**RE: Request for Additional Information, planning permission sought for residential development at the site of 0.57ha at Muldowney's Pub, Main Street, Rathcoole, Co. Dublin.**

**Planning Reg. Ref: SD22A/0096**

Figure 5: Extract of Ground Site Layout proposed for the AI stage.

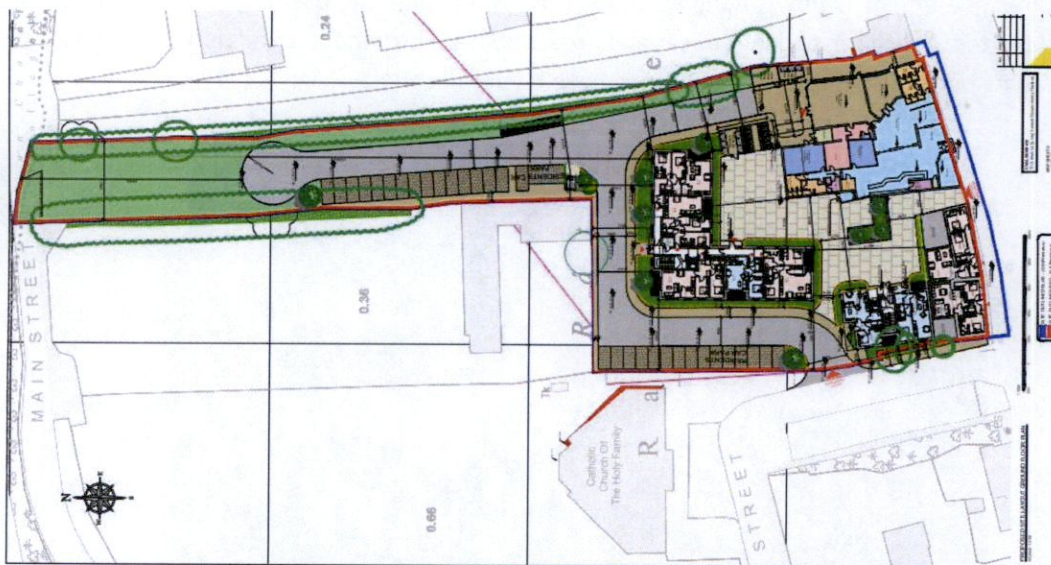
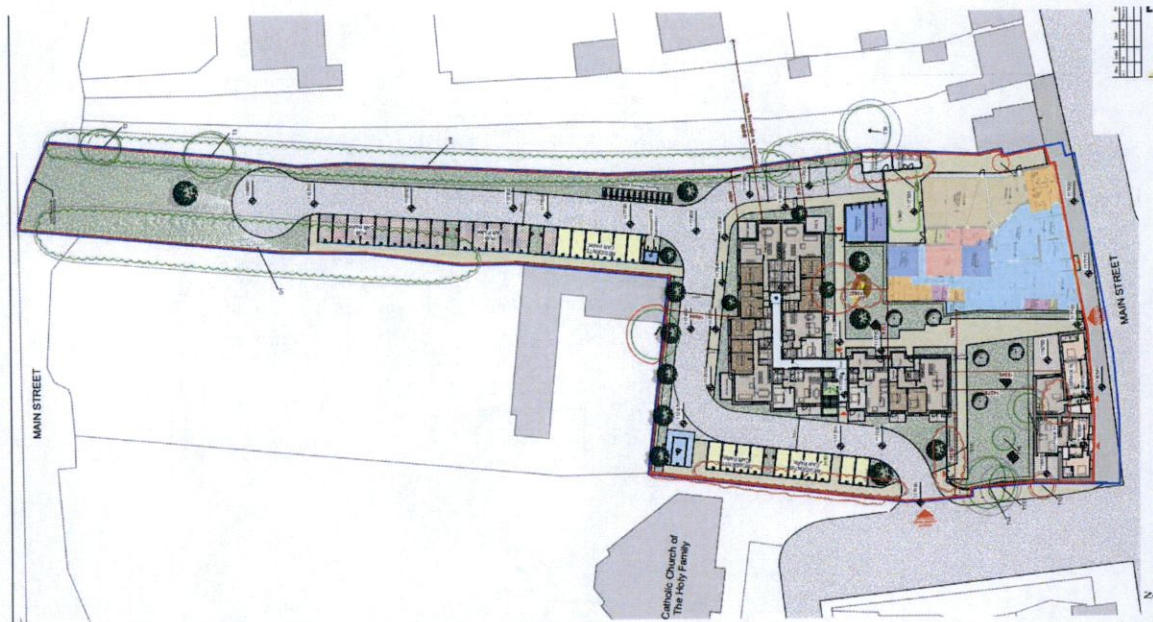
- A)
- (i) *“The southern block (Block A) is linked to the existing cottages to create two L-shaped plan block arrangements around two inner squares which form an urban edge to the western open space and church. It is felt at this area that some separation distance is required to the rear of the corner single-storey cottage allowing a variation of heights and sufficient setback. It is considered that having the 3-storey block directly onto the rear of the corner cottage allows the block to be imposing and completely dominate the single-storey cottages.*

- (ii) Block A should be re-designed to ensure the street frontage element is delivered along with achieved visual connection to Main Street at this location, therefore the design should provide variations in height, levels and roof profiles to reflect a typical streetscape which provides visual interest and variety in design/styles.*

- (iii) Block B requires re-design/revisions to once again provide an overall design that will provide architectural interest as a backdrop to Main Street. Some reduction in height and set back will support a varied design. The use of colour and perhaps different materials would also assist in providing architectural merit and quality defining the architectural quality required within the Village, as part of creating new design and architectural character within the Architectural Conservation Area.*

As shown in the figures below, the proposal has undergone some changes in response to the additional information request. Consideration was given to comments on own-door access, variance in height and commercial use on the ground floor. It was considered to current proposal is more appropriate in the context of the site.

The current proposal replaces the previous two apartment blocks with one, the height remains at 3 storey but it has been set-back from the cottages and main street as a result of the re-design. This provides a more sympathetic approach to the ACA. Own-door units have been provided on the ground floor opening into the communal open space. This provides controlled access to these units. Buffer planting have been provided throughout the scheme to ensure privacy for the end-users. The communal open space remains centralised within the scheme with controlled access to ensure privacy and security for the residents. Pedestrian access from Main Street will be controlled through the use of a key fob for residents only.

Figure 7: Extract of amended proposed development contiguous elevations at AI Stage.

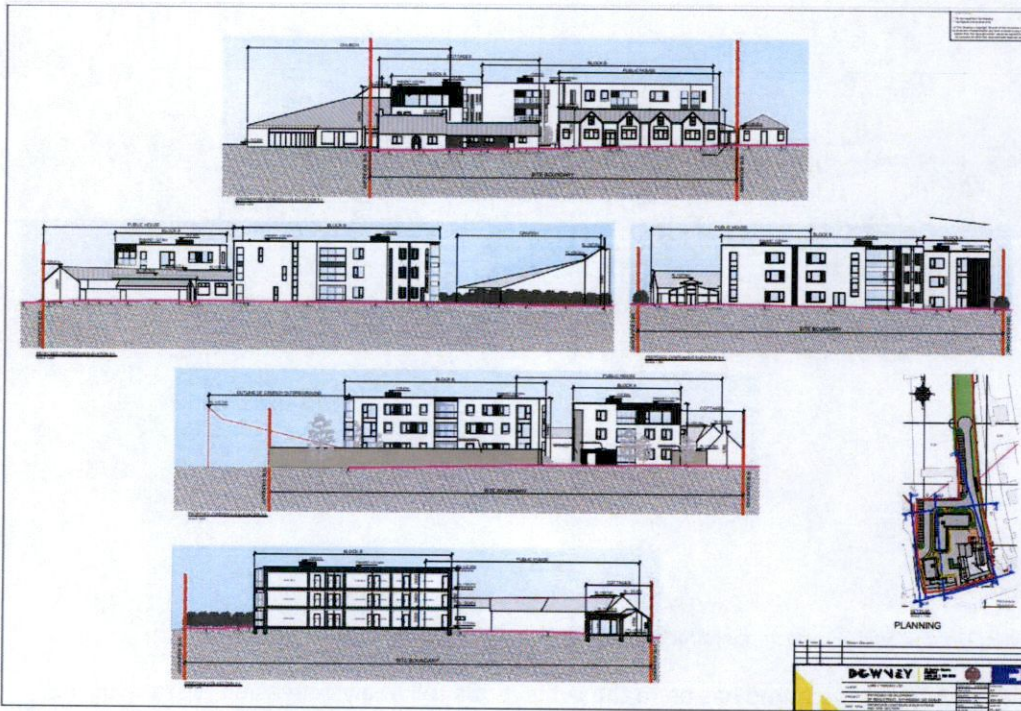
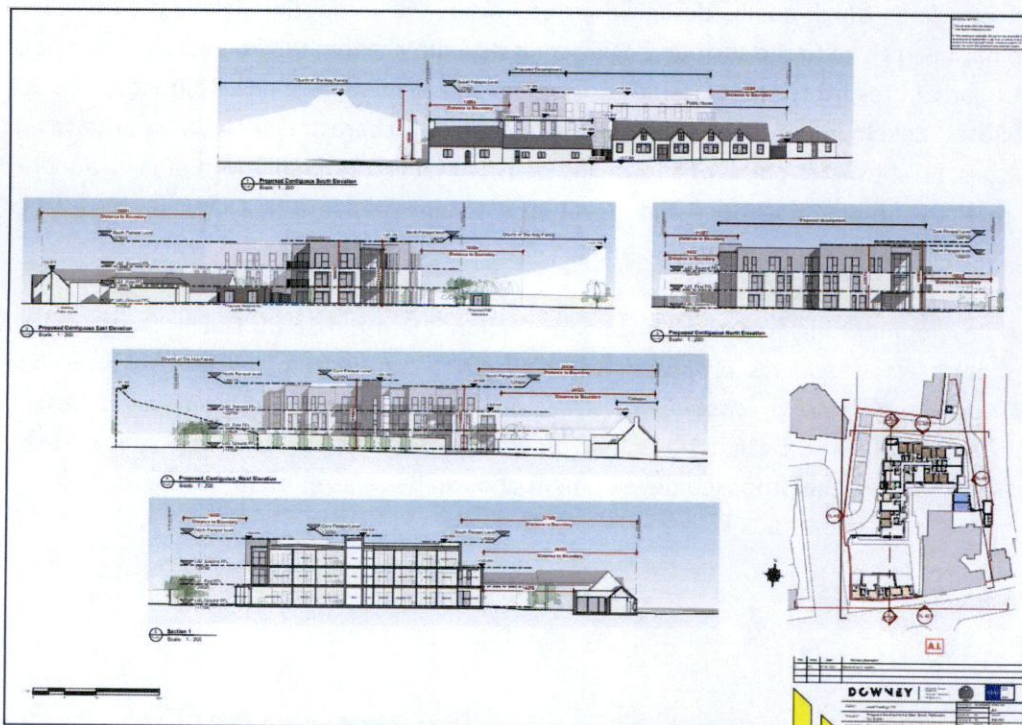
- (iii) The new development at this location needs to provide a greater level of architectural interest and character. The proposed blocks need to achieve a backdrop of add architectural quality and interest to the rear of the existing single-storey cottages and existing public house.*

- (i) It is considered that more consideration needs to be given to the materials and finishes in order to address the above. The height of the blocks needs to show different and varying levels and setback to reflect the different building heights, roof levels/types and architectural character and materials of the existing building stock along Main Street and the village core.*

Figure 8: Extracts from initial site layout and proposed site layout after changes made in the AI stage.

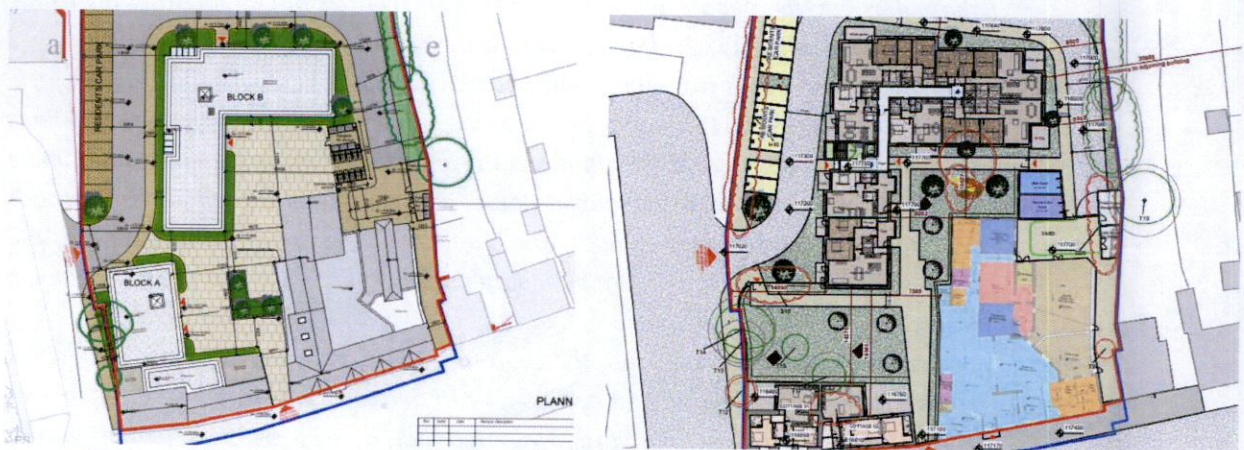
- (iii) *The emergency access from the public house is a major risk, as the enjoyment of the space is dependent on the management of the pub adhering strictly to the conditions of any planning permission. Furthermore, the doorway would likely need to become a party boundary between the public house and the lands owned by an Owner's Management Company set up under the Multi-Unit Developments Act 2011. It is not clear that this would be a secure boundary and this may raise issues with obtaining insurance.*

and terraces (i.e. doubling them in size). The applicant is therefore asked to reconsider these aspects of the development layout, to clarify the purpose of the courtyard and to illustrate either that it is a communal amenity space with adequate privacy and amenity value, or otherwise that the lack of such dedicated community space can be made up for with more generous provision of private balconies and terraces, or alternative communal open space provision. This should be dealt with by additional information.

- (i) The access point from the courtyard to Main Street will now be controlled by key fob for residential use only. This is to be implemented through an electronic key fob access

- (ii) The residents of the proposed development will have communal open space of 633 sq. m, which exceeds the minimum standards set out within the apartment guidelines (2022). The communal space within the courtyard is to consist of a small child play area, in which the apartments will provide passive surveillance for safety. Access from the south and west, will now also be controlled access points for residential use only. Again, this will be implemented through electronic key fob access.

- (iii) The emergency access from the public house has been altered so that it does not open onto the communal area of the residential development. DOWNEY have consulted with a fire consultant who has advised on the re-design of the internal layout of the Pub to provide for an alternative emergency access point. Please refer to the revised drawings prepared by DOWNEY and submitted under separate cover for further information.

- (iv) The windows facing onto the courtyard space are to be removed and replaced with skylights, to ensure that the issue of noise and odours will not harm the residential amenities offered by the courtyard. This allows for the uninterrupted use of the communal space by the residents and reduces the need to provide additional balcony space which may not be as flexible a use.

**Figure 9: South Dublin County Development Plan 2022 - 2028 Land Zoning Maps, with Aviation Overlay. Subject site denoted in red outline.**

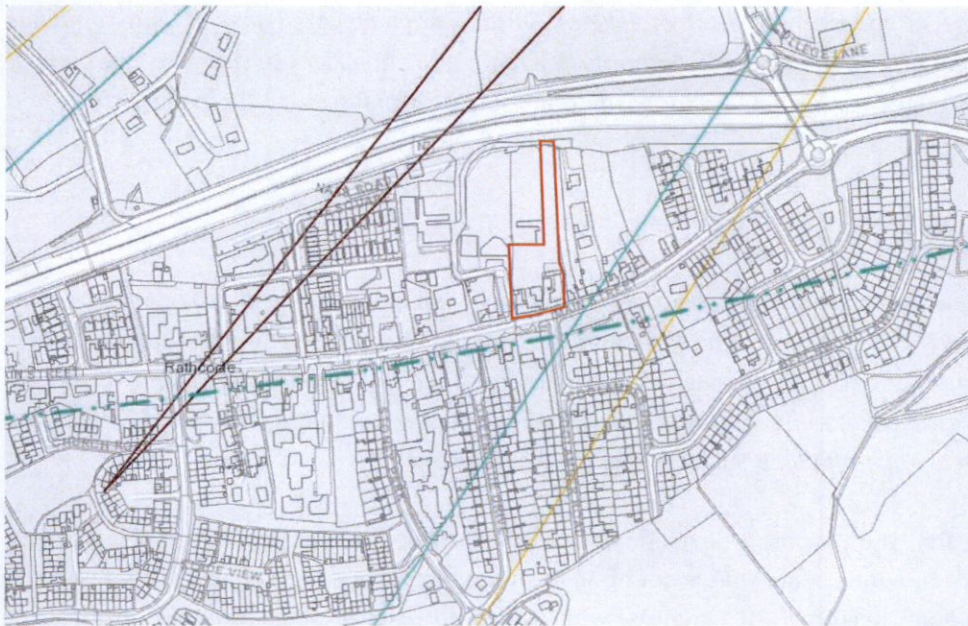
(A) *"The site is located in the 'critical safety zone', underneath the runway approach to runway 05. Section 7.8.1 of the County Development Plan identifies runway 05/23 as being a secondary runway. The site is not located in the inner approach zone, where development is not permissible. As per Policy IE8 objective 3(c), and the County Development Plan maps, "the ICAO standards will not prejudice the development of zoned lands in Rathcoole". The applicant has not addressed the issue of aviation safety, either in terms of noise or building height/ obstacle limitations. They should provide comment by way of additional information. As per Section 11.6.6 of the Development Plan, the Planning Authority request the applicant to submit a longitudinal section through the relevant Approach Surface funnel. The section drawing shall include the following: - The Ordnance Datum (OD) of the relevant runway, - The approach surface slope for the relevant runway in accordance with Table 3 & 4 of the IAA Guidance Material on Aerodrome Annex 14 Surfaces (2015) The OD of the highest point and OD of the predominant height of the proposed development, - A range of OD reference points for the existing ground levels on the subject site, - The horizontal distance of the subject site from the Aerodrome, and - Heights of existing permanent obstacles in the vicinity of the site if applying the principle of shielding (see Section 3.23 of the Irish Aviation Authority Guidance Material on Aerodrome Annex 14 Surfaces, 2015). - The distance from threshold shall be taken into account in the section drawing.*

DOWNEY submit to the council that the proposed development does not meet the criteria of requiring part (A) of this additional information request, due to the recently adopted South Dublin County Development Plan 2022 – 2028, and revisions to policies and objectives in regard to aviation safety. There has been revisions of policies and objectives in regard to Casement Aerodrome, in which we will provide a justification as to why this additional request is not relevant to the subject site as of present day.

DOWNEY submit that the proposed development does not fall under the 'critical safety zone' (known as the 'Inner Public Safety Zone' and 'Outer Public Safety Zone' in the recently adopted Development Plan) and is therefore not subject to revising the issue of aviation safety in this regard.

Figure 13: Extract from submitted landscape plan in response to additional information.

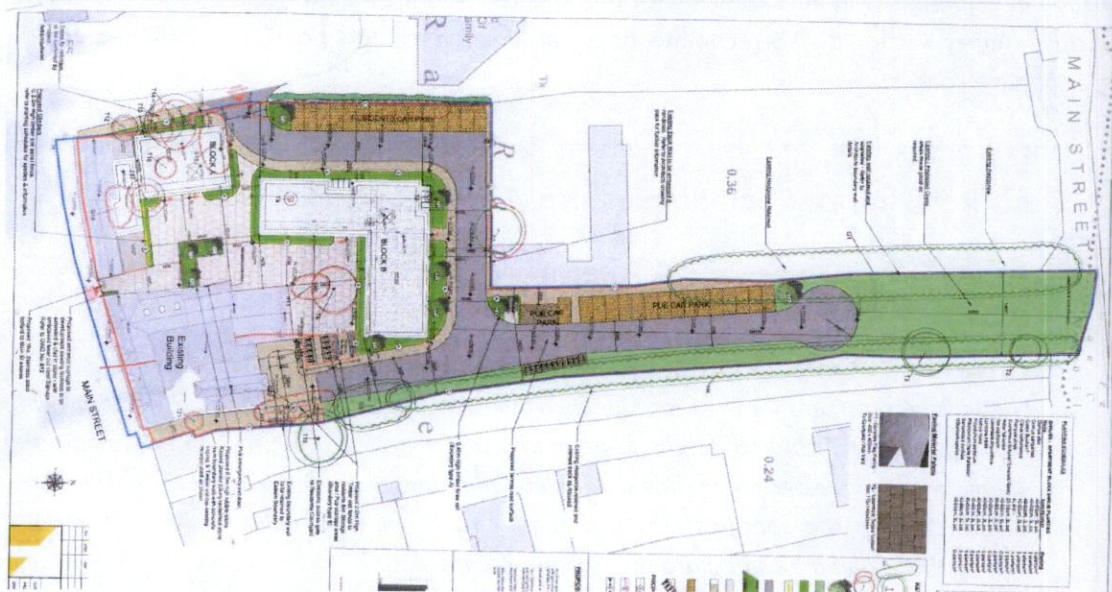
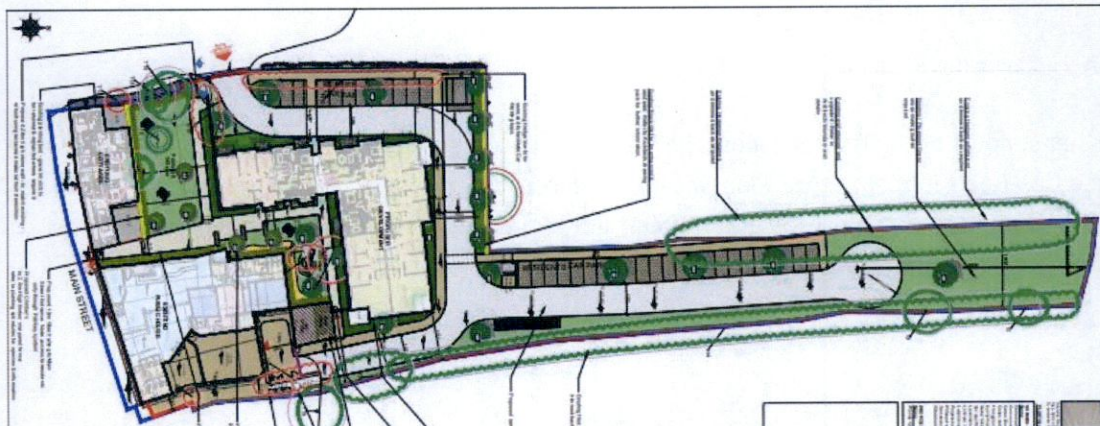
*There are concerns with the lack of information submitted in terms of a landscaping scheme and boundary treatment for the proposed development. The applicant is requested to provide a landscape design including details of boundary treatment for the proposed development. The applicant is requested to provide a detailed landscape plan with full works specification, that accords with the specifications and requirements of the Public Realm Section. The landscape Plan should include hard and soft landscape details; including levels, sections and elevations, detailed design of SUDs features including integrated/bio retention tree pits. In addition, the applicant is requested to submit a landscape rationale. The landscape proposals should be prepared by a suitably qualified landscape architect.*

DOWNEY submit that the proposed development has included for revisions to the proposed public realm of the development, and that it reflects a scheme of higher quality. Existing hedgerows are retained where it is feasible to do so. A provision of tree planting is to be provided to make-up for the loss of natural vegetation which will result in a net increase provision of green infrastructure for the proposed development.

The landscape proposals indicate that the residents of the proposed development will have communal open space of 633 sq. m, which exceeds the minimum standards set out within the apartment guidelines (2022) which state a minimum of 171 sq. m of communal open space should be provided. The communal space within the courtyard is to consist of a small play area, in which the apartments will provide for active and passive surveillance for safety.
